EA802 Whitewater Hall

Replace Operable Windows and Interior Renovation
IU#20240646

ADDENDUM NO. 2

24 October 2025

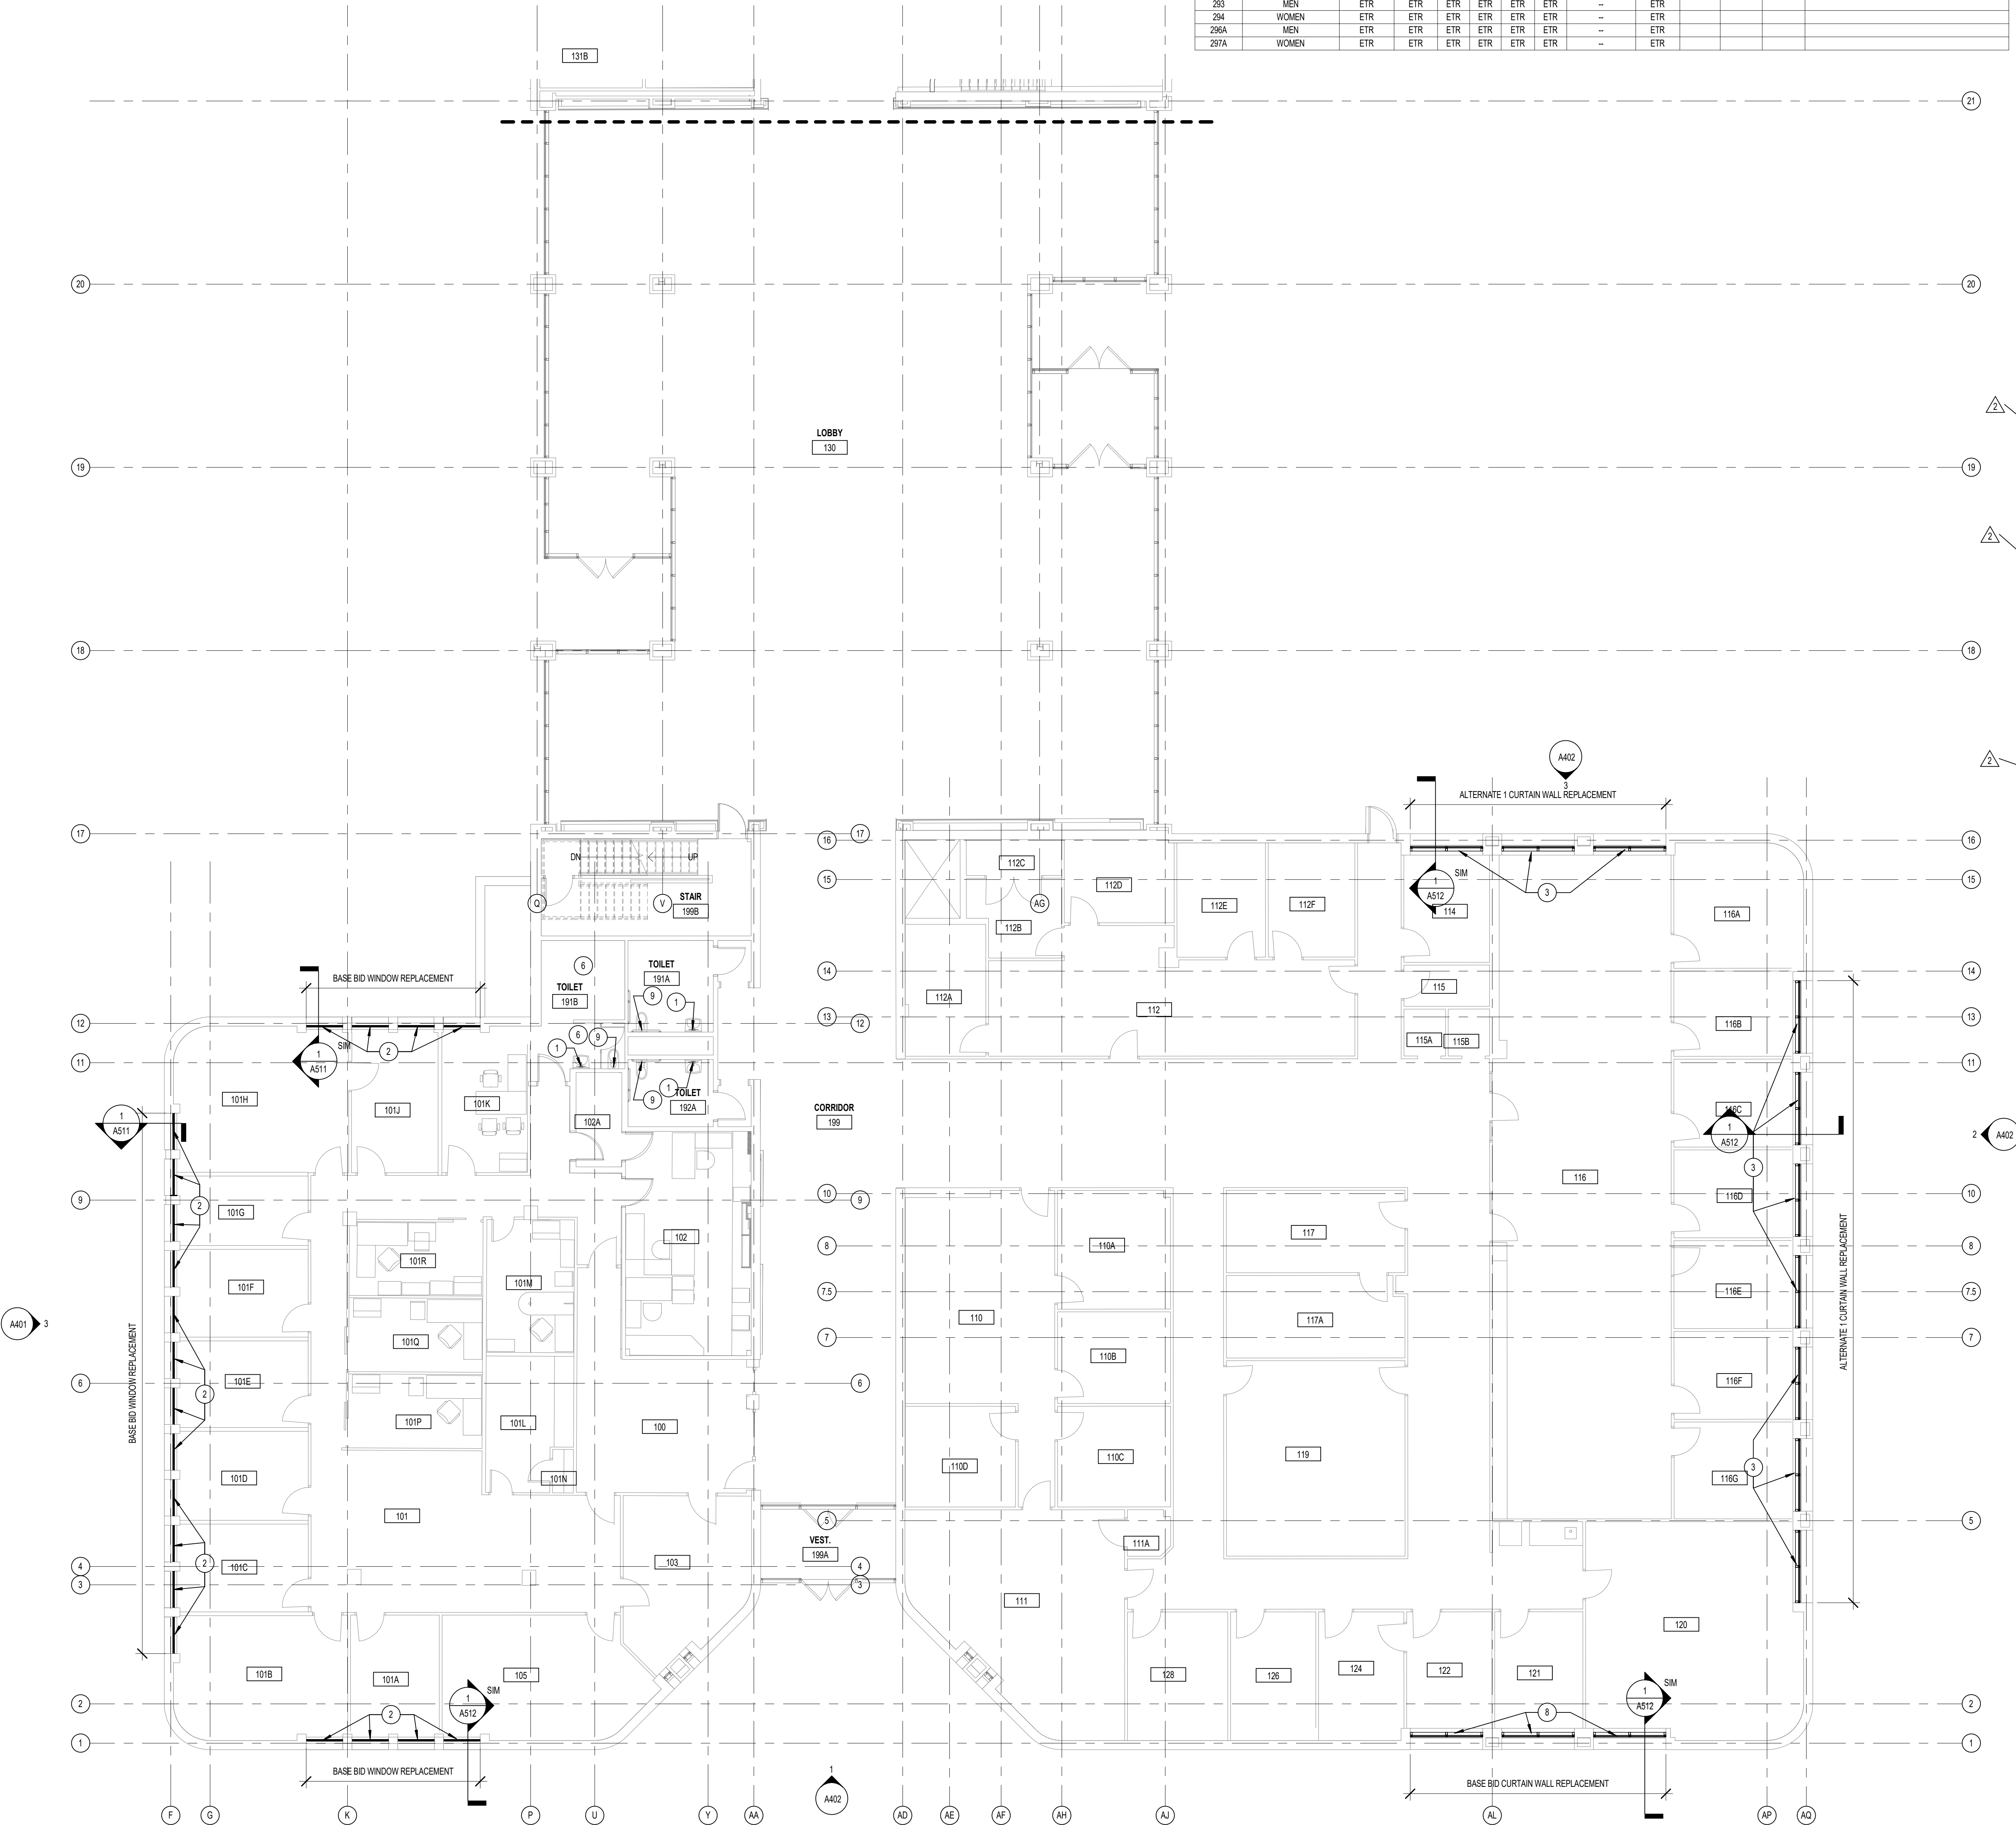
1. Sheet A221 – Second Floor Plan - Southwest
 - a. Revise General Plan Note 16 as shown on attached revised sheet.
 - b. Revise Specific Floor Plan Notes 2, 3, 4, 5, and 8 as shown on attached revised sheet.
2. Sheet A222 – Second Floor Plan – Northeast
 - a. Revise General Plan Note 16 as shown on attached revised sheet.

15. PROVIDE MOLD RESISTANT DRYWALL AT ALL LOCATIONS SPECIFIED IN THE PROJECT MANUAL.
16. ALL UNIT HEATERS TO BE REPAINTED AT EXTERIOR WINDOWS AS PART OF BASE BID/ALTERNATE. BRUSH PAINTING OF UNIT HEATERS SHALL BE INCLUDED IN EITHER BASE BID OR ASSOCIATED ALTERNATE WINDOW REPLACEMENT.

1. BASE BID: EXISTING PORCELAIN FIXTURES TO REMAIN. CONTRACTOR TO REPLACE TRIM. REFER TO PLUMBING INFORMATION, TYP.
2. BASE BID: PROVIDE NEW ALUMINUM FRAMED WINDOW IN EXISTING OPENING. COORDINATE WITH EXISTING UNIT HEATER TO REMAIN. UNIT HEATER TO BE BRUSH PAINTED. PROVIDE NEW ROLLER SHADE AT WINDOW.

3. ALTERNATE 1: PROVIDE NEW ALUMINUM FRAMED CURTAIN WALL SYSTEM IN EXISTING OPENING. COORDINATE WITH EXISTING UNIT HEATER TO REMAIN. UNIT HEATER TO BE BRUSH PAINTED. PROVIDE NEW ROLLER SHADE AT CURTAIN WALL LOCATION.

4. ALTERNATE 2: PROVIDE NEW ALUMINUM FRAMED CURTAIN WALL SYSTEM IN EXISTING OPENING. COORDINATE WITH EXISTING UNIT HEATER TO REMAIN. UNIT HEATER TO BE BRUSH PAINTED.

5. BASE BID: PROVIDE NEW ALUMINUM FRAMED WINDOW IN EXISTING OPENING. COORDINATE WITH EXISTING UNIT HEATER, INTERIOR WALL FRAMING, AND VENTS TO REMAIN. UNIT HEATER TO BE BRUSH PAINTED. PATCH AND REPAIR WALL AS REQUIRED TO RECOVER WINDOWS AND REINS ALL VENTS.

6. BASE BID: PATCH AND REPAINT EXISTING WALLS THIS SPACE.
7. BASE BID: PROVIDE NEWLY RESISTANCE FILM ON EXISTING WINDOW IN ART GALLERY.
8. BASE BID: PROVIDE NEW ALUMINUM FRAMED CURTAIN WALL SYSTEM IN EXISTING OPENING. COORDINATE WITH EXISTING UNIT HEATER TO REMAIN. UNIT HEATER TO BE BRUSH PAINTED. PROVIDE NEW ROLLER SHADE AT CURTAIN WALL LOCATION.

SECOND FLOOR
PLAN -
NORTHEAST
A222

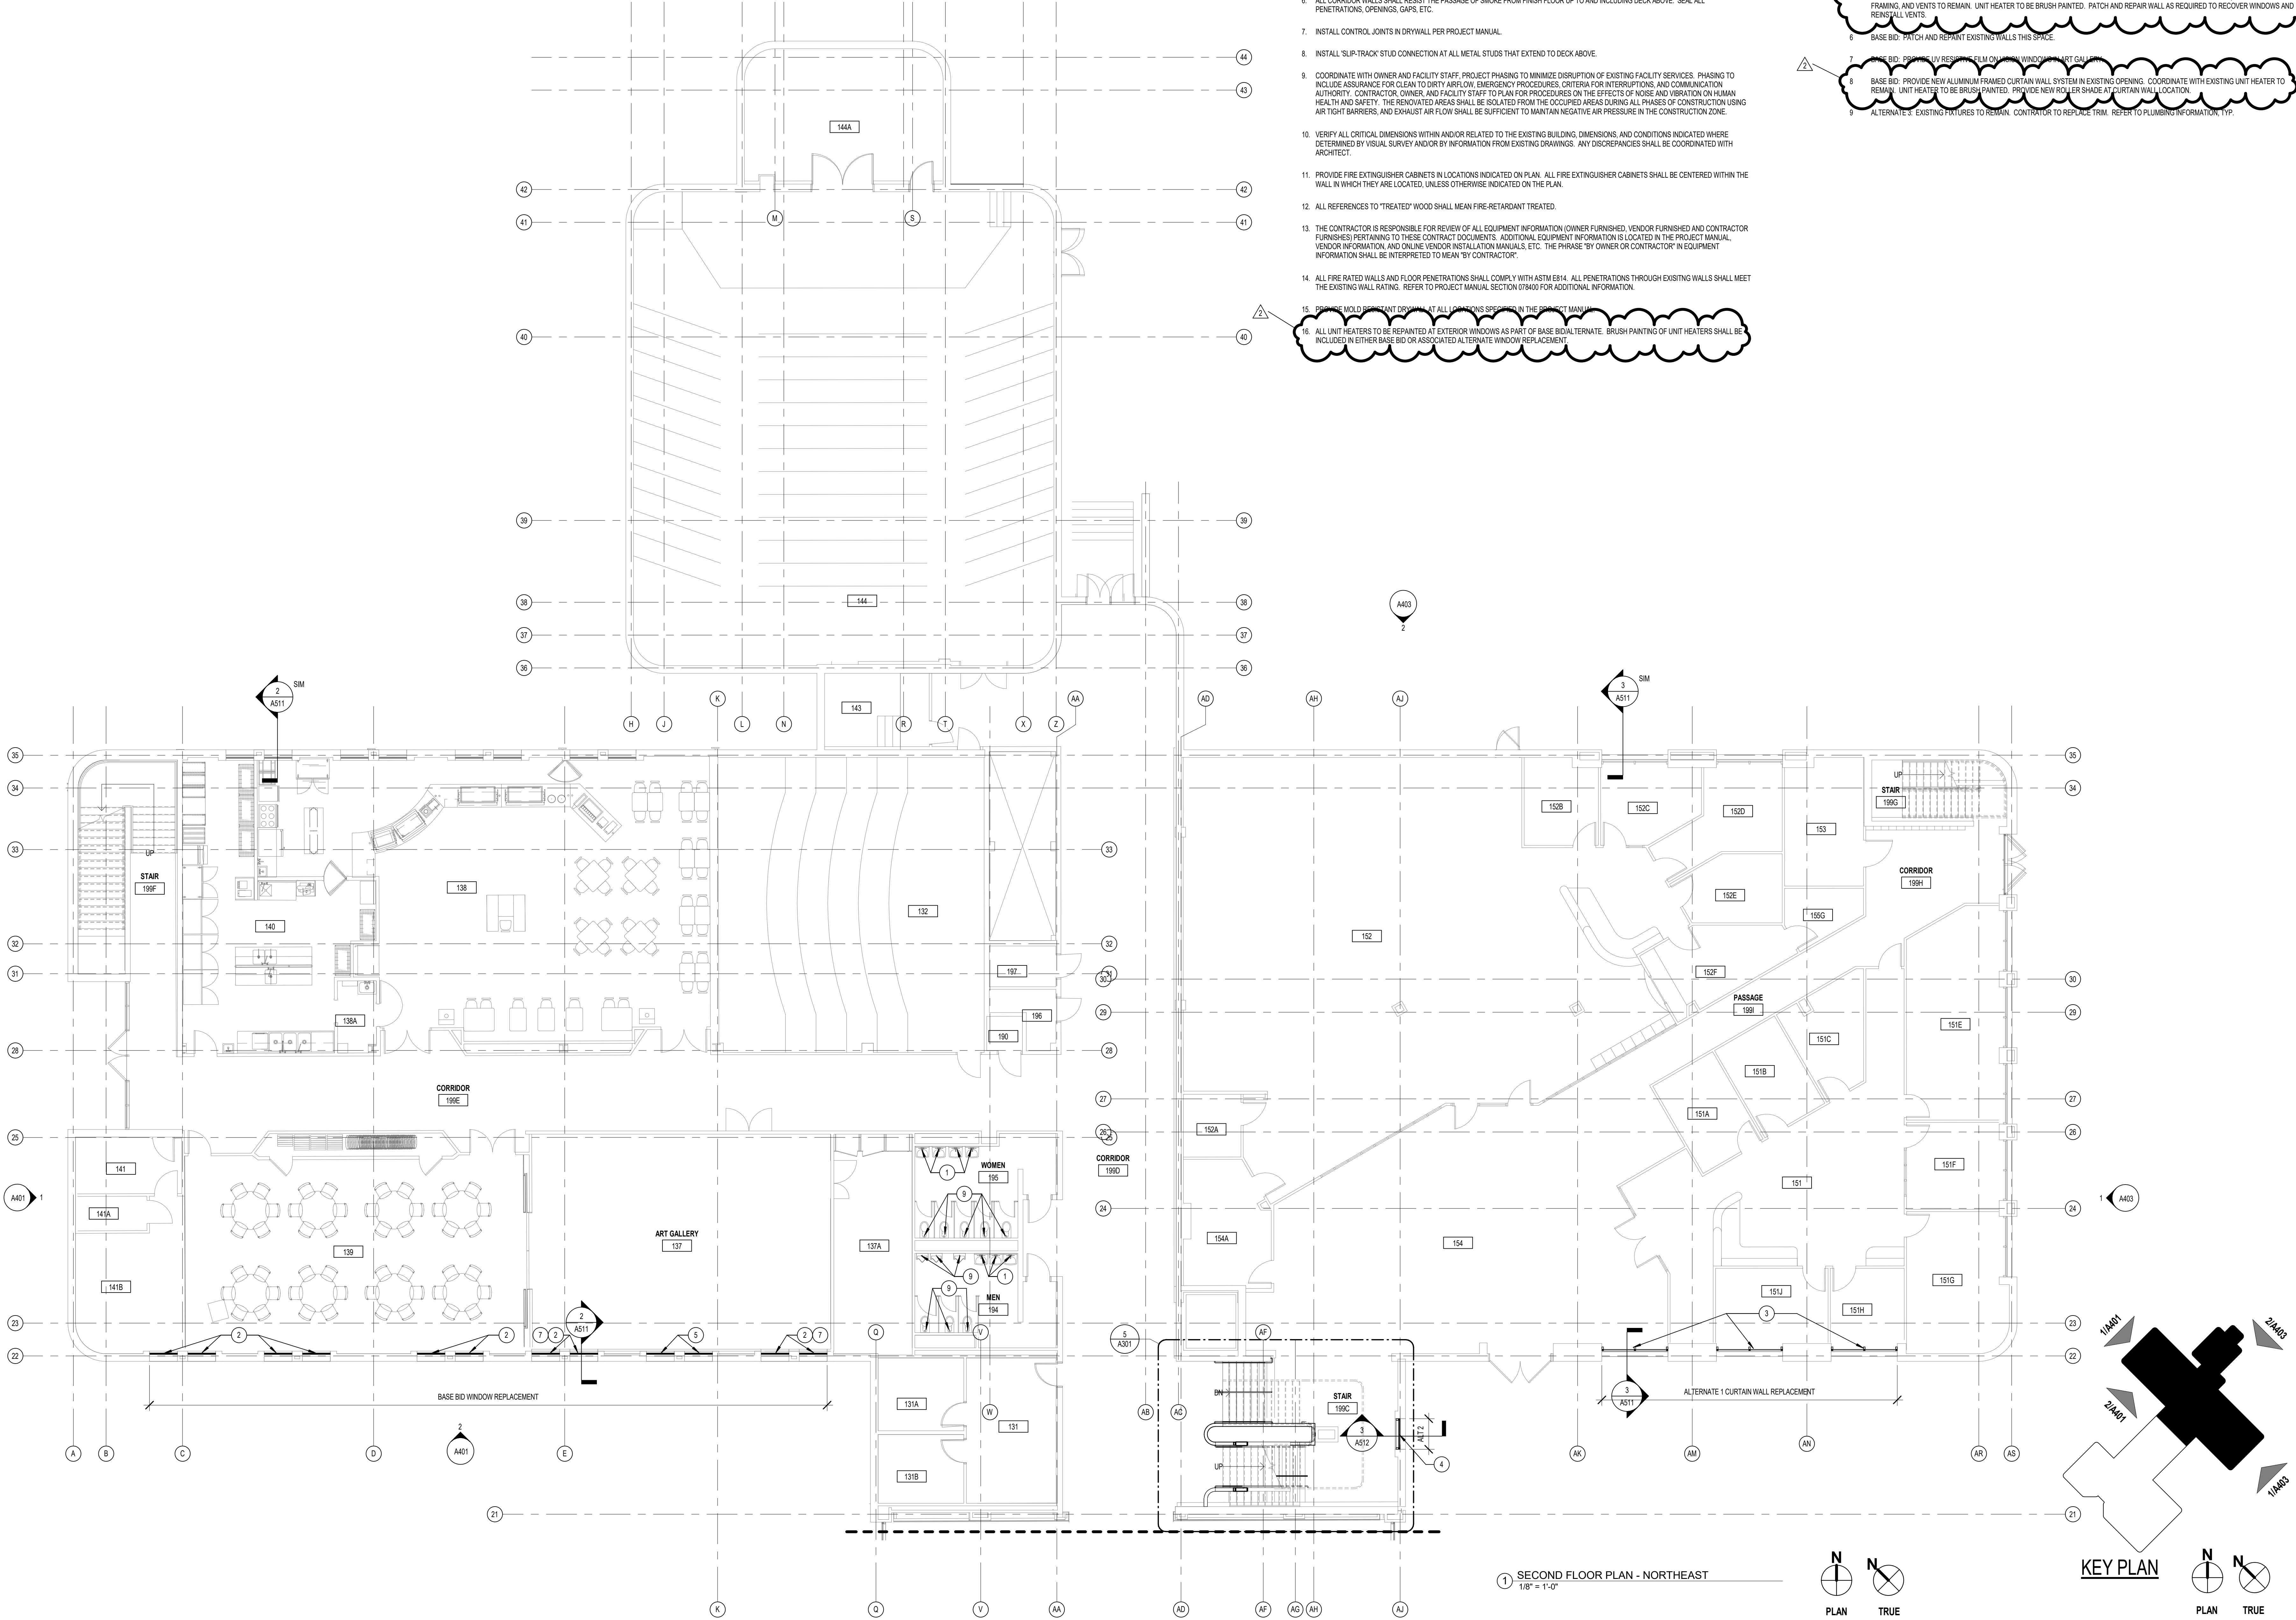
-
- b. Revise Specific Floor Plan Notes 2, 3, 4, 5, and 8 as shown on attached revised sheet.
 - 3. Sheet A231 – Third Floor Plan – Southwest
 - a. Revise General Plan Note 16 as shown on attached revised sheet.
 - b. Revise Specific Floor Plan Notes 2, 3, 4, 5, and 8 as shown on attached revised sheet.
 - 4. Sheet A232 – Third Floor Plan – Northeast
 - a. Revise General Plan Note 16 as shown on attached revised sheet.
 - b. Revise Specific Floor Plan Notes 2, 3, 4, 5, and 8 as shown on attached revised sheet.

1. BASE BID: EXISTING PORCELAIN FIXTURES TO REMAIN. CONTRACTOR TO REPLACE TRIM. REFER TO PLUMBING INFORMATION, TYP.
2. BASE BID: PROVIDE NEW ALUMINUM FRAMED WINDOW IN EXISTING OPENING. COORDINATE WITH EXISTING UNIT HEATER TO REMAIN. UNIT HEATER TO BE BRUSH PAINTED. PROVIDE NEW ROLLER SHADE AT WINDOW.

3. ALTERNATE 1: PROVIDE NEW ALUMINUM FRAMED CURTAIN WALL SYSTEM IN EXISTING OPENING. COORDINATE WITH EXISTING UNIT HEATER TO REMAIN. UNIT HEATER TO BE BRUSH PAINTED. PROVIDE NEW ROLLER SHADE AT CURTAIN WALL LOCATION.

4. ALTERNATE 2: PROVIDE NEW ALUMINUM FRAMED CURTAIN WALL SYSTEM IN EXISTING OPENING. COORDINATE WITH EXISTING UNIT HEATER TO REMAIN. UNIT HEATER TO BE BRUSH PAINTED.

5. BASE BID: PROVIDE NEW ALUMINUM FRAMED WINDOW IN EXISTING OPENING. COORDINATE WITH EXISTING UNIT HEATER, INTERIOR WALL FRAMING, AND VENTS TO REMAIN. UNIT HEATER TO BE BRUSH PAINTED. PATCH AND REPAIR WALL AS REQUIRED TO RECOVER WINDOWS AND REINS ALL VENTS.

6. BASE BID: PATCH AND REPAIR EXISTING WALLS THIS SHADE.
7. BASE BID: PROVIDE UV RESISTIVE FILM ON VISION WINDOWS IN ART GALLERY.
8. BASE BID: PROVIDE NEW ALUMINUM FRAMED CURTAIN WALL SYSTEM IN EXISTING OPENING. COORDINATE WITH EXISTING UNIT HEATER TO REMAIN. UNIT HEATER TO BE BRUSH PAINTED. PROVIDE NEW ROLLER SHADE AT CURTAIN WALL LOCATION.
